**TOWN OF OCEAN RIDGE
PLANNING & ZONING REGULAR MEETING
AGENDA**

**March 17, 2026 at 9:00 AM
Town Hall - Meeting Chambers**

To:	Planning & Zoning Board Members
From:	Corey O’Gorman, Town Planner
Meeting Date:	March 17, 2025
Subject:	20 Hudson Avenue – Development Plan Review

PLAN REVIEW REPORT
20 Hudson Avenue
01/04/26/Revision 02/02/26

1 Site plan
A.100 Scale: 3/64" = 1'-0"

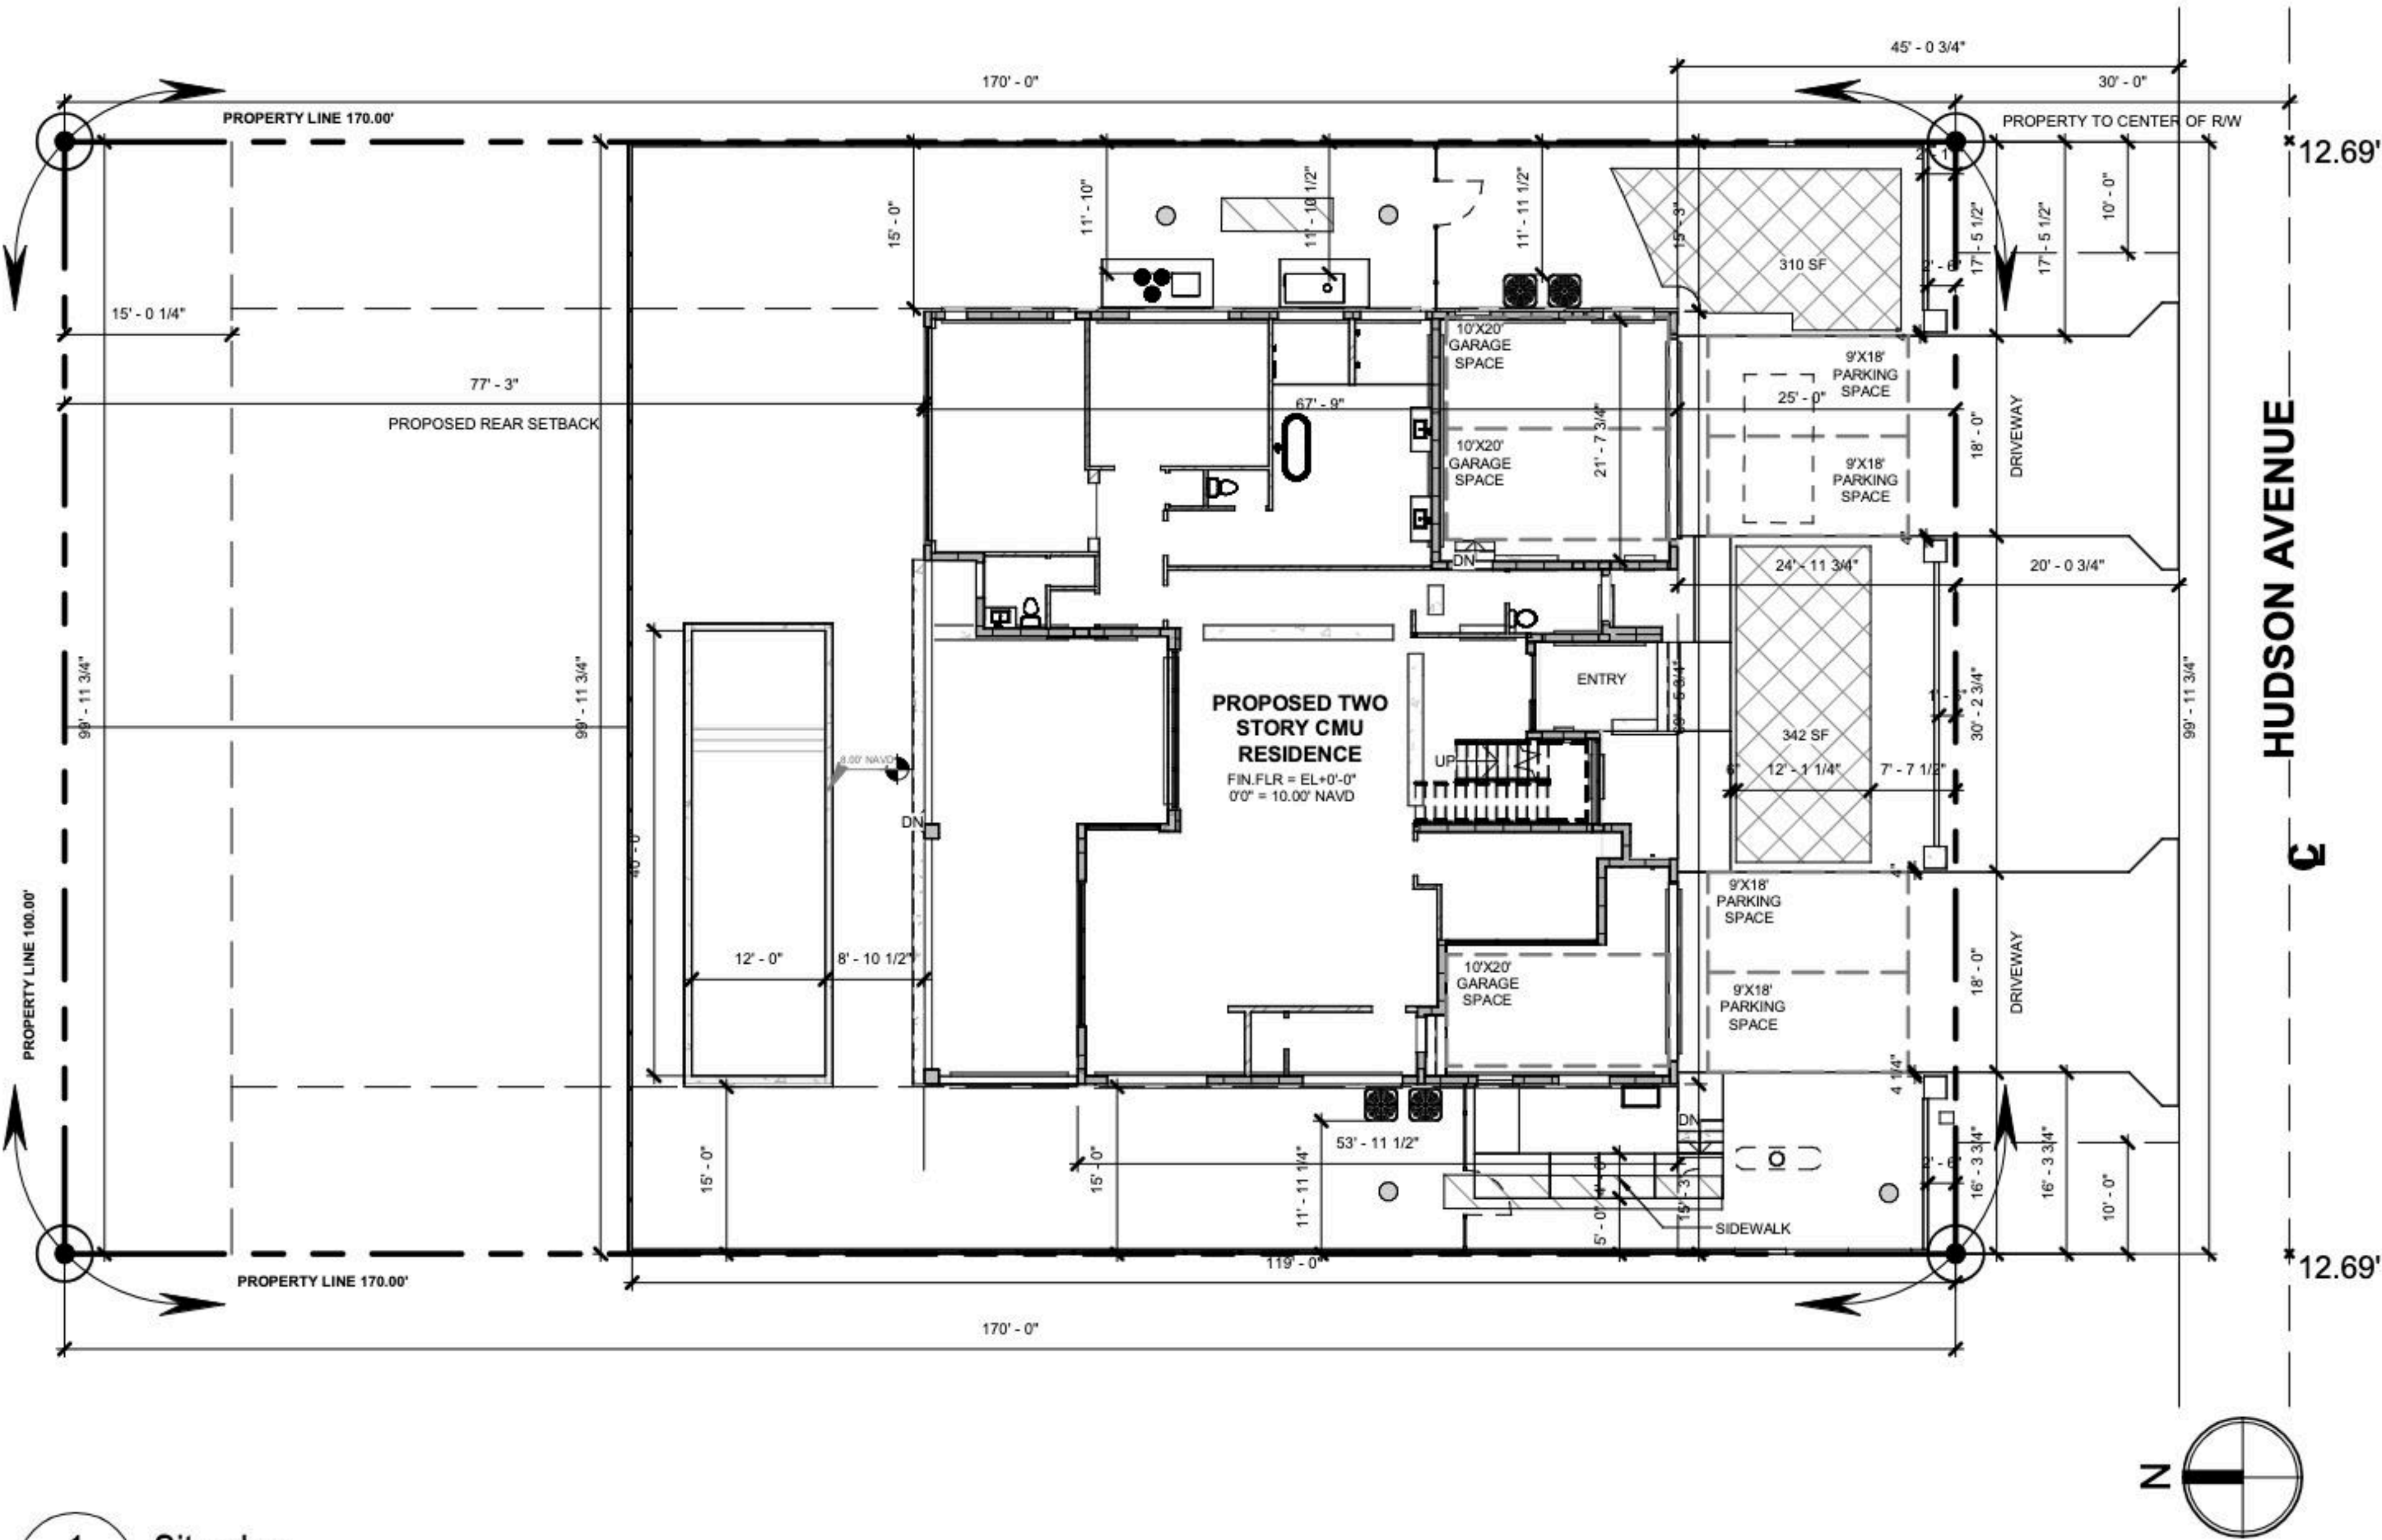
Section 64-1(j)(2) ~~**Background:** This code section requires a 15' side setback, and although the site plan sheet A-100 shows side setbacks dimensioned at 15' 3", the site data table shows 14' 9".~~

~~**Comment:** Please revise the site data table on sheet A-100 to be consistent the setbacks as dimensioned.~~ **Comment addressed**

Owner: 20 Hudson LLC
Address: 20 Hudson Avenue, Ocean Ridge, FL
Sheet: WEST & EAST ELEVATIONS
OPENING RATIO

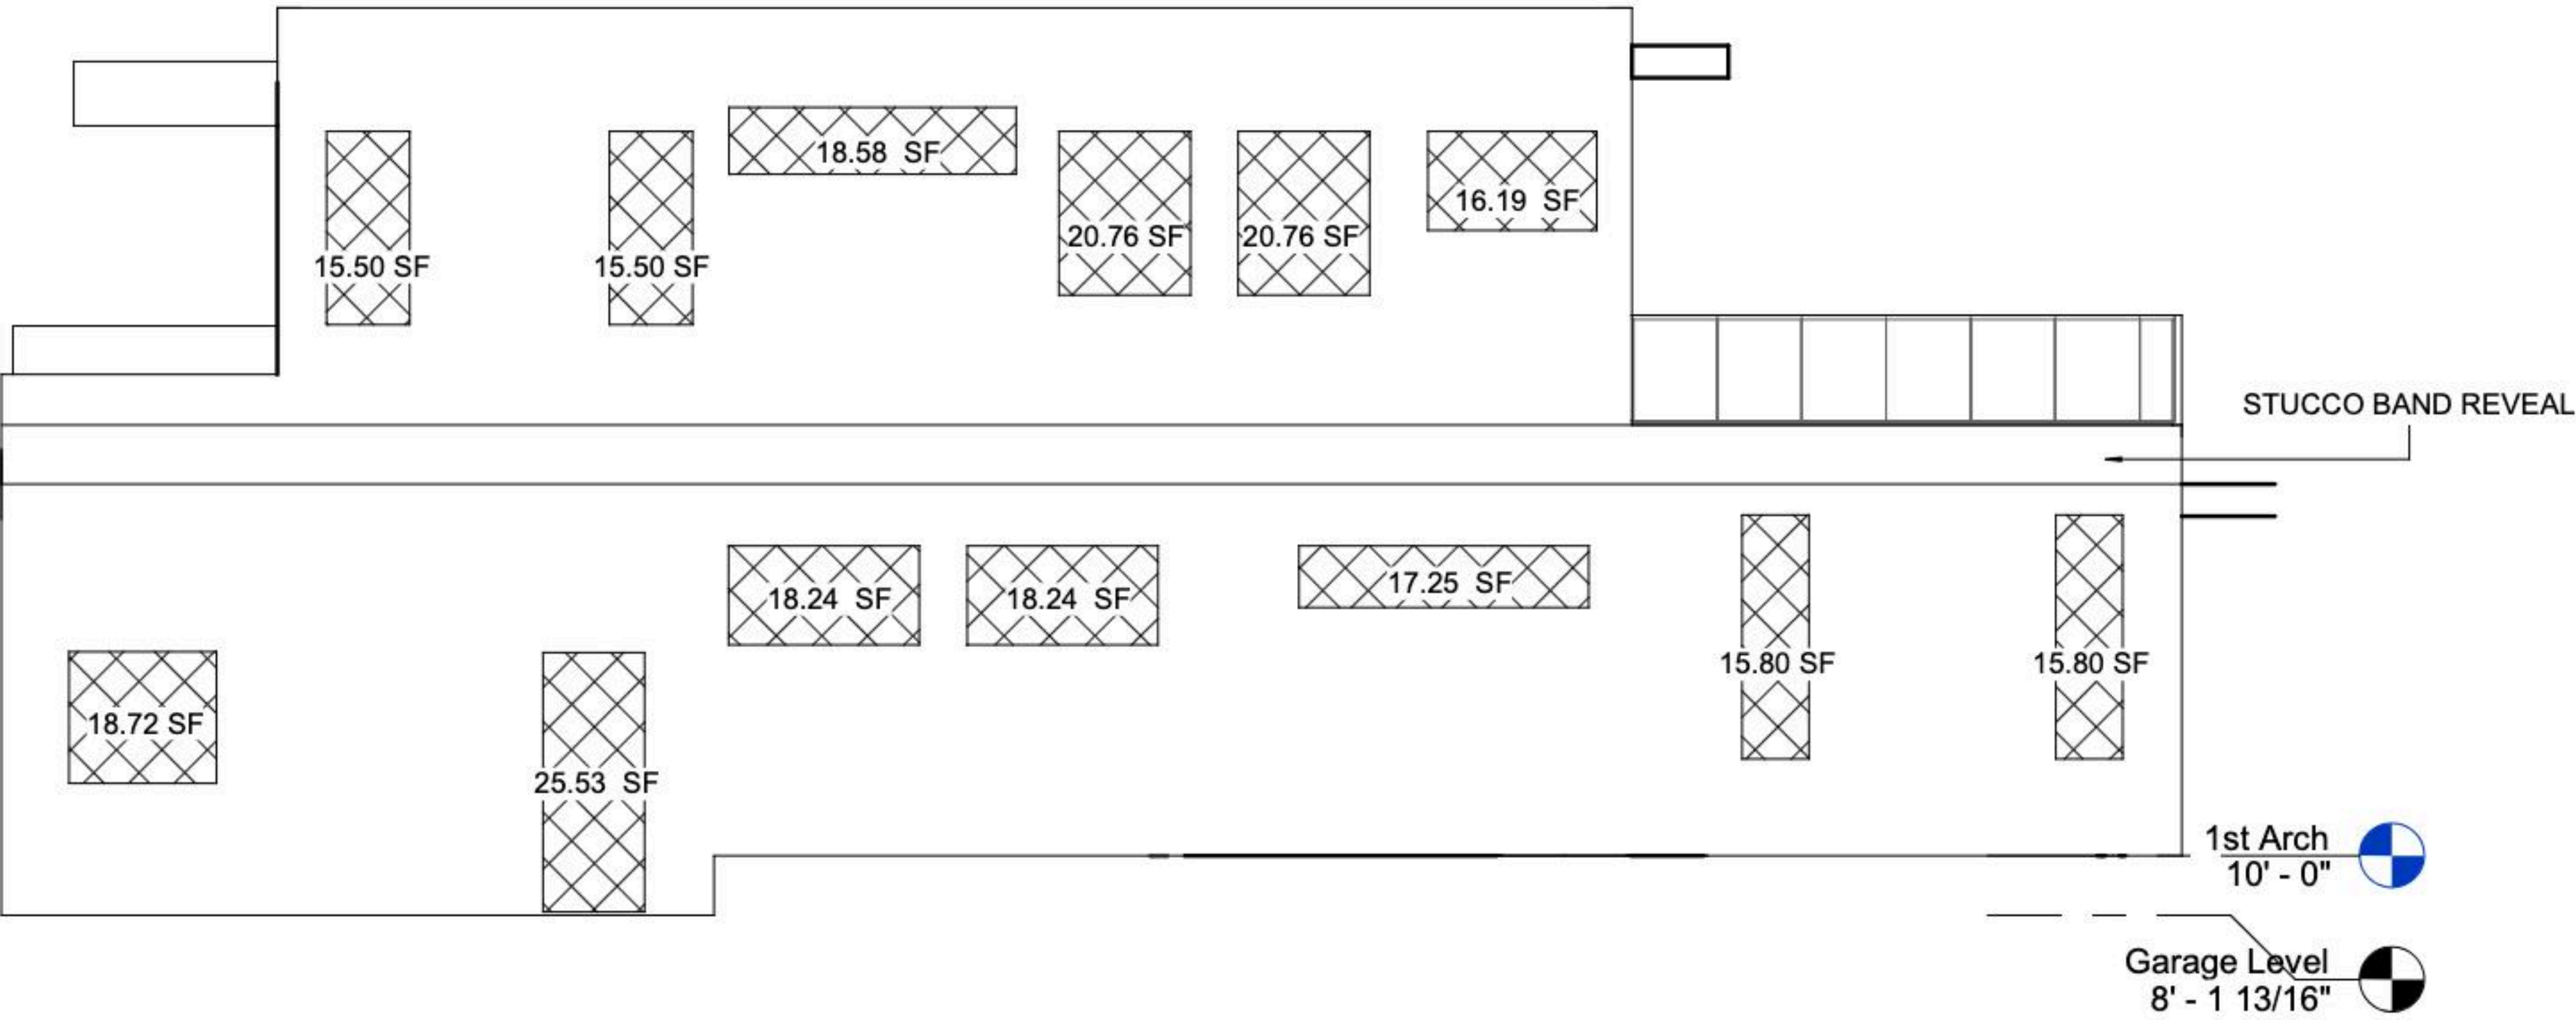
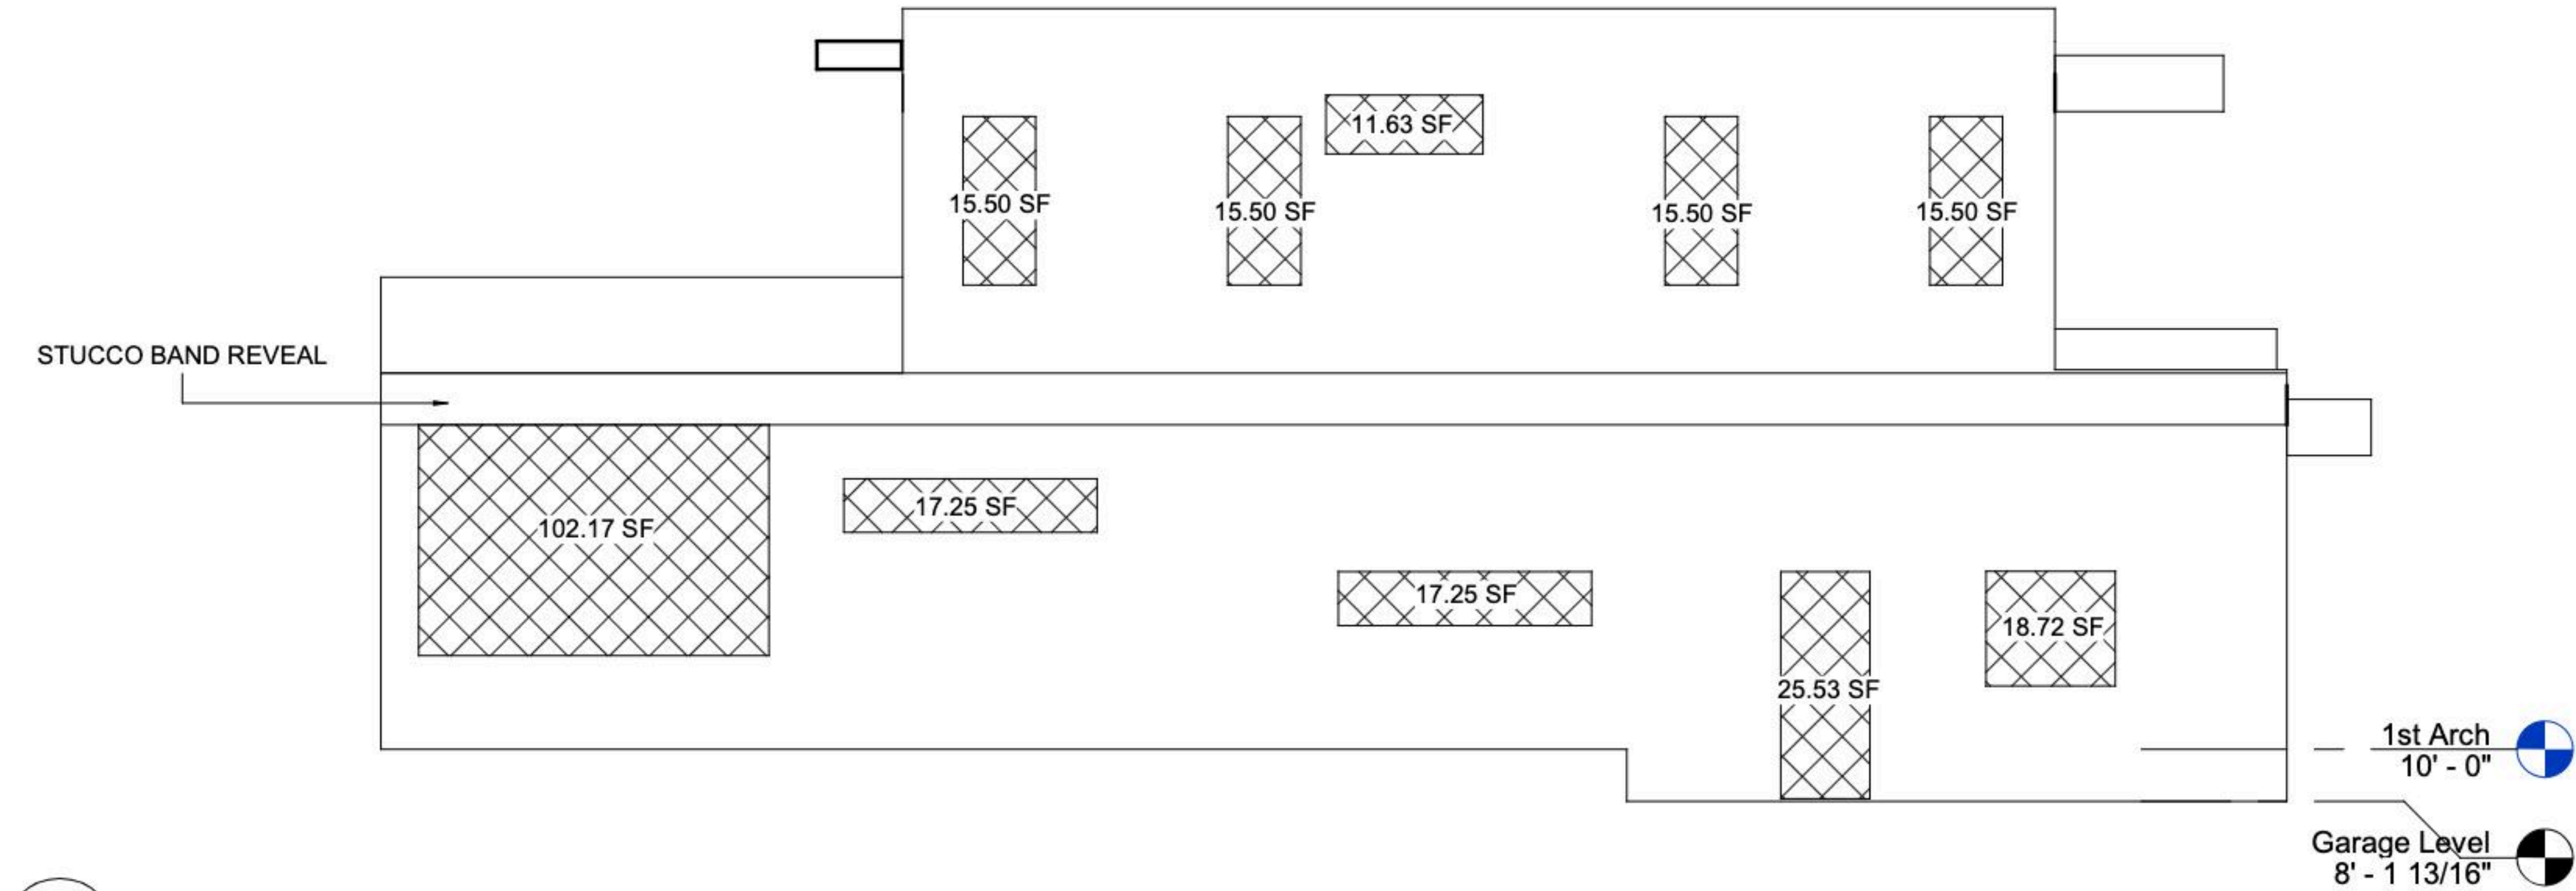
~~**Comment:** Please revise Sheet A-105 and any related sheets to demonstrate compliance with the substantial articulation requirements.~~
Comment addressed.
